UNITED STATES PATENT AND TRADEMARK OFFICE

APPLICATION NO.	FILING DATE	FIRST NAMED INVENTOR	ATTORNEY DOCKET NO.	CONFIRMATION NO.
10/729,366	12/08/2003	Sami Sagol	1268-203	8244

Office Action Summary

A H schment A

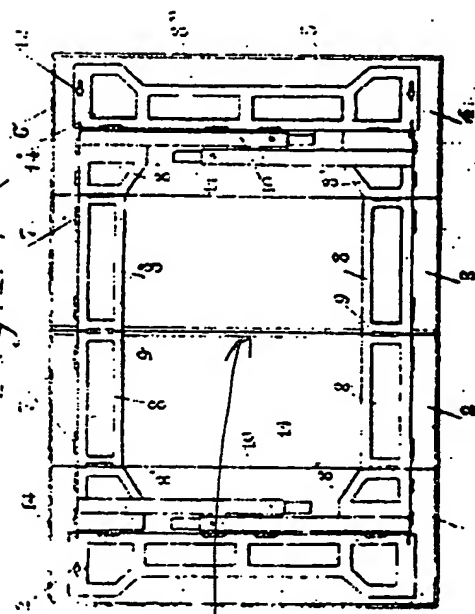
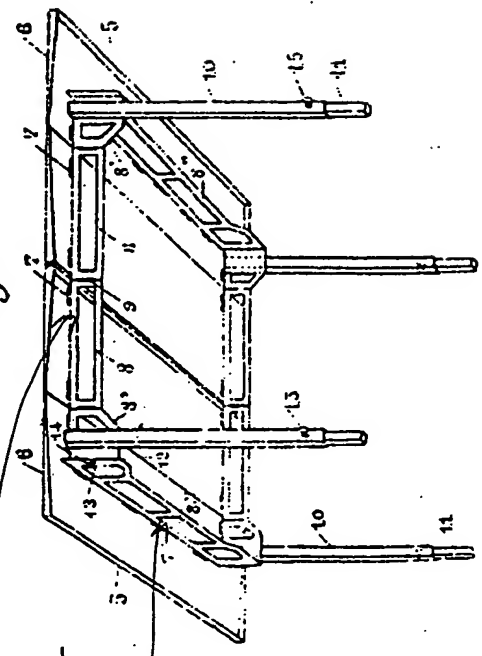
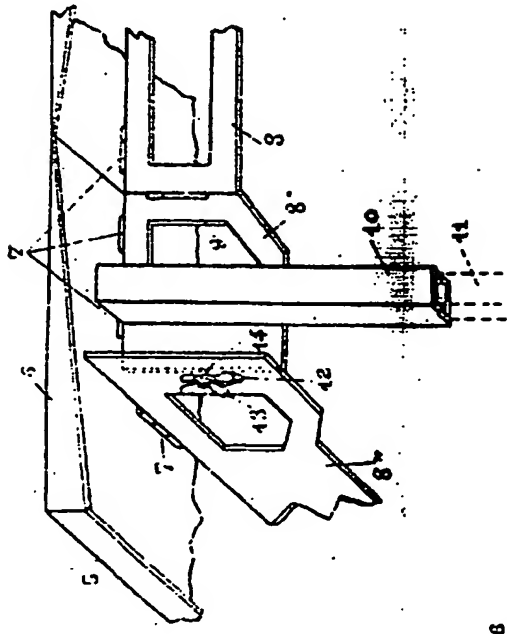
Claims 1, 3, 5, 10-12, 21, 23 and 30 are rejected under 35 U.S.C. 102(b) as being anticipated by French patent 738,868. The French reference teaches a collapsible table (Figs. 1-3; see Attachment A) comprising a table top formed of a pair of pivotable

table top half-sections (1/2 and 3/4) hinged to one another at their adjacent edges along a center-line of the table and displaceable between an open position where said half-sections are coplanar and a folded position where said half-sections overlap one another; the table characterized in that each section has at an undersurface thereof a transverse support member (8 both portions) pivotally articulated thereto with a leg (10) associated with each lateral edge of each transverse support member, and a pair of longitudinal support members (8) pivotally articulated to the undersurface; said support members are displaceable between erect and collapsed positions whereby the transverse support members are prohibited from collapsing as long as at least one of the longitudinal support members is erect. The half sections further include abutment surfaces (adjacent touching edges formed at the hinge line of the table top) and a skirt (6).
